Product Change Notification

Type of Notification: Changing Zener diode (ZD71)

LDC30F-□

Fig.2.1 Photograph of "Existing" and "Changed"

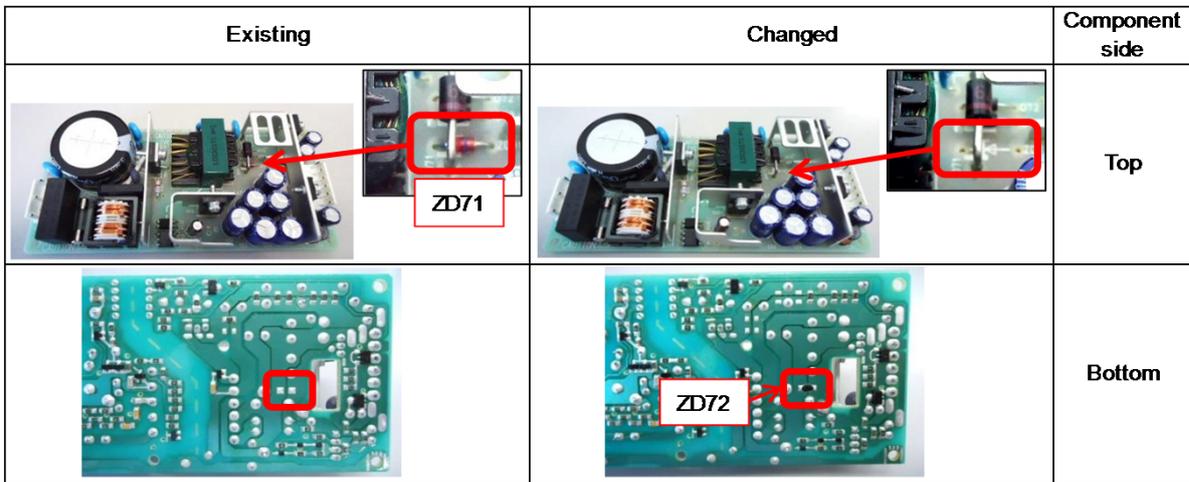
Following component is reaching the end of production life, and an equivalent component will be replacing it (See table below).

No.	Model	Contents	Existing	Changed
1	LDC30F-1	Parts number	ZD71	ZD72
		Manufacturer	Panasonic	Panasonic
		Type name	MAZ2360	DZ2W360
		Package	Axial	SMD
		Zener voltage	36V	36V
		Power dissipation	1W	1W
2	LDC30F-2	Parts number	ZD71	ZD72
		Manufacturer	Panasonic	Panasonic
		Type name	MAZ2430	DZ2W430
		Package	Axial	SMD
		Zener voltage	43V	43V
		Power dissipation	1W	1W

* Parts Number: ZD71 was changed to ZD72 (ZD71 became a vacant number).
